METROPOLITAN GOVERNMENT OF NASHVILLE AND DAVIDSON COUNTY

STAFF RECOMMENDATION
3603 Meadowbrook Ave
June 15, 2016

Application: New construction—addition; Partial demolition
District: Richland-West End Neighborhood Conservation Zoning Overlay
Council District: 24
Map and Parcel Number: 10405027900
Applicant: Adam Sneed, property owner
Project Lead: Melissa Sajid, melissa.sajid@nashville.gov

Figure 1. 3603 Meadowbrook Avenue.

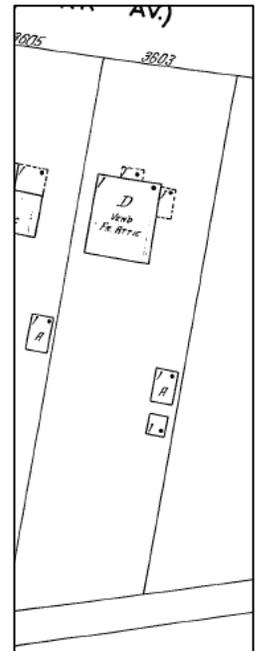
Background: The house located at 3603 Meadowbrook Avenue was built c. 1915 and is a bungalow with a clipped side gabled roof (Figure 1). The house contributes to the historic character of the Richland-West End Neighborhood Conservation Zoning Overlay.

Figure 5: 1996 footprint (Property Assessor)

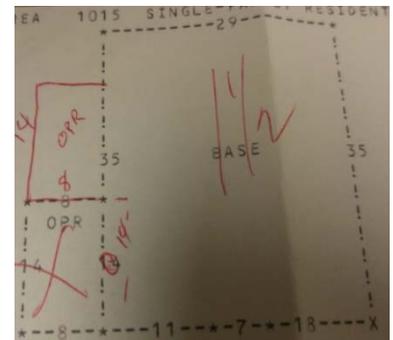
Partial Demolition: The application proposes to demolish an existing side screened porch that is located on the left side of the house. Research indicates that the existing covered side porch is not the original side porch shown on the 1931 Sanborn maps (Figure 2). In this case, the side porch is nearly flush with the front of the house, which is also evident in the 1968 Property Assessor’s photo (Figure 3). Subsequent photos and footprints, however, show that the location of the side porch was relocated fourteen feet (14’) back from the front of the house (Figures 4 and 5). Consequently, staff finds that the existing covered side porch is not contributing as it has been either demolished and rebuilt or significantly altered with relocation.

Demolition without reconstruction of the original or existing porch is necessary to provide vehicular access on this lot that does not have alley access.

As the plan proposes to remove non-contributing addition, staff finds the proposed demolition meets Section III.B.2 for appropriate demolition and does not meet Section III.B.1 for inappropriate demolition.

A LEFT ELEVATION
A-5 SCALE: 1/8" = 1'-0"

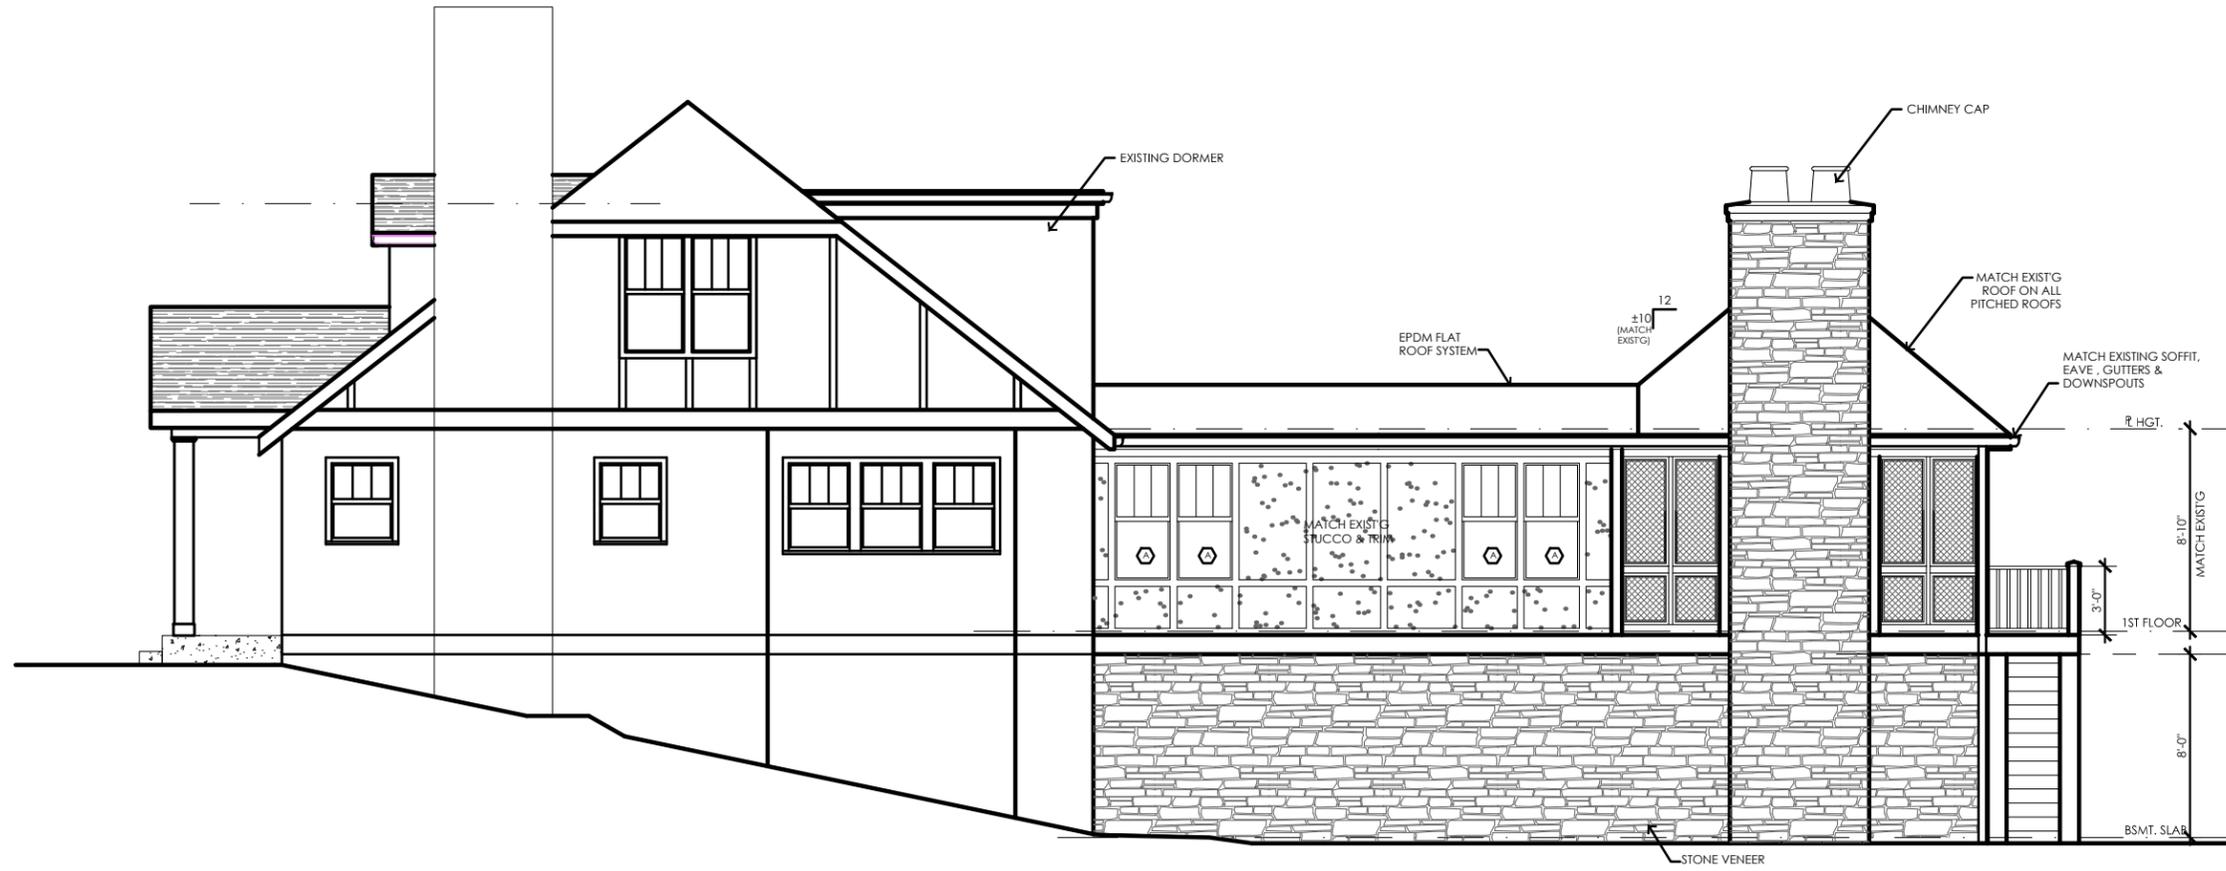
The addition has a maximum ridge height that is approximately eight feet (8') less than the ridge of the historic house. The foundation line matches the existing foundation. Eave height on the addition is also similar to that on the existing house.

Roof form: The roof form of most of the addition is flat, but the rear part of the addition is a clipped gable with a roof pitch of 10/12 that complements the existing historic house. The flat roof system ties into an existing rear dormer addition that also has a flat roof form. The roof of the proposed covered stoop will be flat as well. Staff finds that the proposed roof forms are compatible with the historic house and meet Sections II.B.1.e. and II.B.2. of the design guidelines.

Proportion and Rhythm of Openings: The windows on the proposed addition meet the historic proportion of openings, being generally twice as tall as they are wide. There are no large expanses of wall space without a window or door opening. Staff finds the project's proportion and rhythm of openings to meet Sections II.B.1.g. and II.B.2. of the design guidelines.
